**Trinity River Channel Rehabilitation Site:
Bucktail (River Mile 105.45-107.0)
Draft Environmental Assessment/Initial Study
DOI-BLM-CA-N060-2015-0057-EA and TR-EA0215**

November 2015

**Part 1: Document cover through Appendix A (cover to page A-30)
Part 2: Appendix B: Response to Comments part 1 (page B-1 to B-52)
Part 3: Appendix B: Response to Comments part 2 through
Appendix D (page B-53 to D-4, end of document)**

Figure 23.B.1. Percent change of Fry and Presmolt Salmonid Rearing Habitat at Channel Rehabilitation Sites (2008-2012) at Trinity River flows between 300 and 450 cfs.

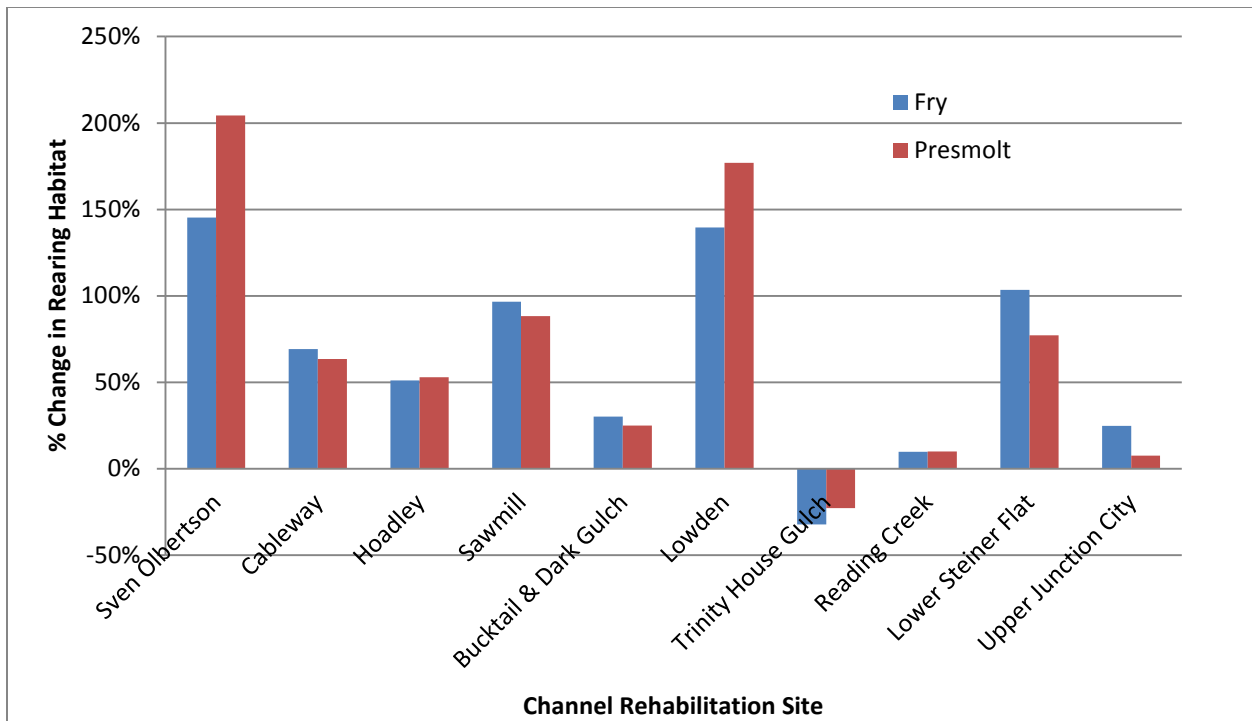
Comment 23.B – Program review.

The proposed channel rehabilitation projects are supported by data and evaluations consistent with the findings of, but not assessed in, the Scientific Advisory Board's (SAB) draft Phase 1 review report (complete title: Review of the Trinity River Restoration Program's channel rehabilitation strategy, Phase 1; SAB Draft 2013). There are several factors to consider when attempting to apply findings from the SAB's draft Phase 1 review: (1) the report is in technical review and is subject to revision; (2) quotes from the draft report need to be considered in context with associated explanations of data limitations to retain their meaning; and (3) the draft report evaluates "Phase 1" channel rehabilitation projects only (projects constructed between 2005 and 2010).

Lessons learned from Phase 1 are being incorporated into the Phase 2 design process. The site design reports developed for the Phase 2 sites commonly include explicit descriptions and analysis of how individual site elements are expected to change over time in relation to variable flows. These descriptions showcase the continued adaptive nature of the channel rehabilitation site design process. The Program incorporates public input to designs at the conceptual and intermediate stages and proposed designs are vetted through public meetings and public participation in technical work group meetings. Designers integrate physical models to predict how sites will perform and evolve under different flow regimes. With current models, the designers may choose alternative implementation scenarios to increase/enhance juvenile salmonid rearing habitat, restore fluvial processes, and restore proper riparian function. Figure 23.B.1, below, shows how juvenile rearing habitat, between pre and post-construction condition, has changed at recent channel rehabilitation sites (USFWS unpublished data*).

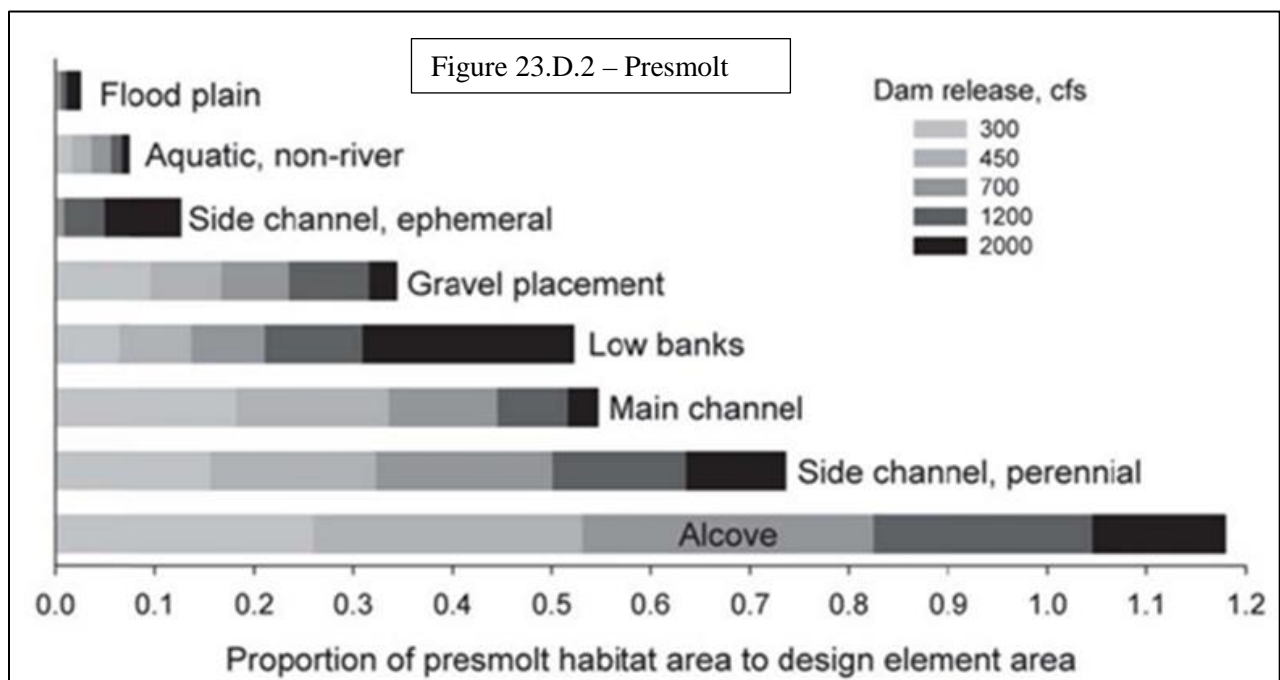
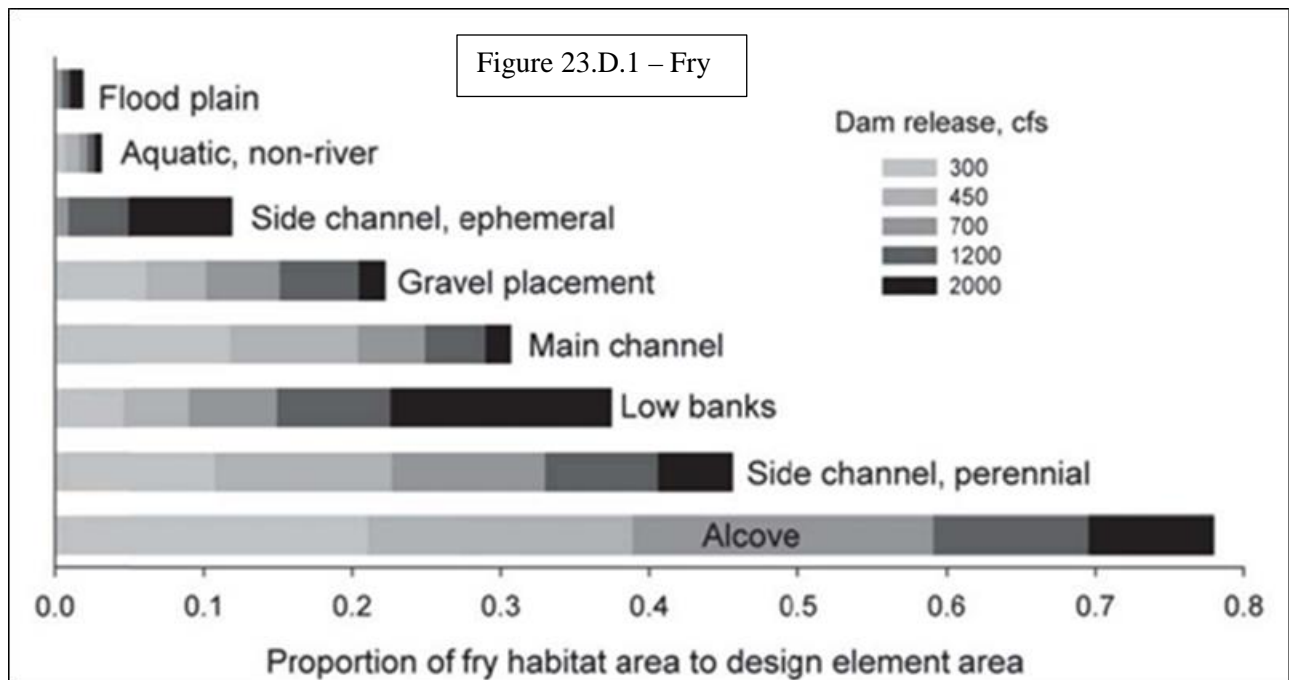
Comment 23.D. – Channel rehabilitation inconsistent with ROD.

The goals and objectives of the Program as described in the ROD remain the same, as do the purpose and need. Technological developments and channel rehabilitation strategies modified through adaptive management have combined to meet ROD objectives. Techniques to increase rearing habitat have evolved to include construction of large wood structures and alcoves (SAB draft report; Martin et al. 2012). These, along with the establishment or expansion of side-channels, continue to be mechanisms for creating low velocity, high-value habitat. (See Figures 23.D.1 and 23.D.2). Phase 2 projects will continue to incorporate designs with features that produce the largest amount of rearing habitat at a wide range of flows, and that promote dynamic alluvial reaches (e.g., large wood elements).

Figure 23.U.1. Counts of female spring-run Chinook carcasses showing pre-spawn mortality or spawned condition.

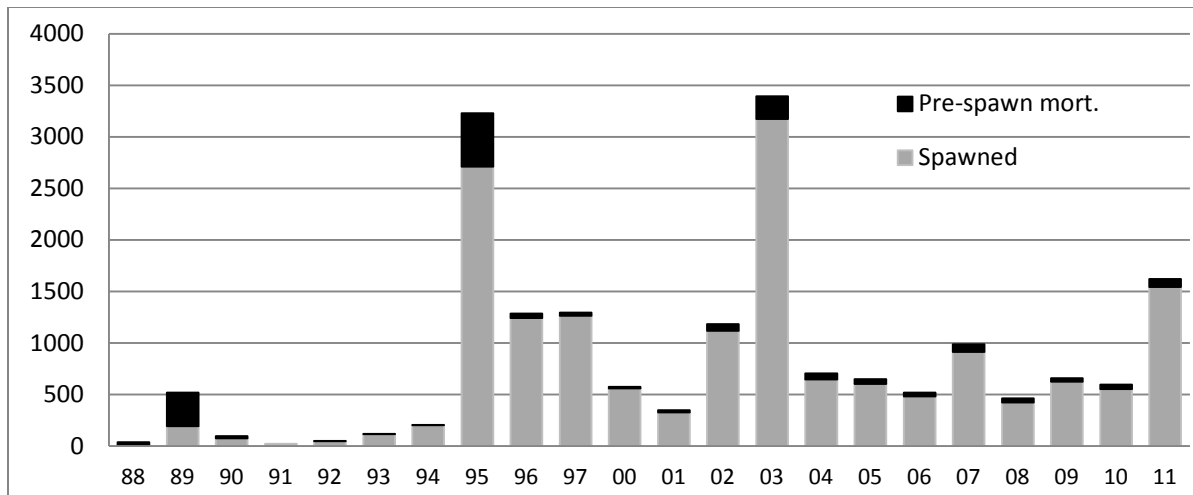
Comment 23.U - Adult salmonid holding habitat and pool filling.
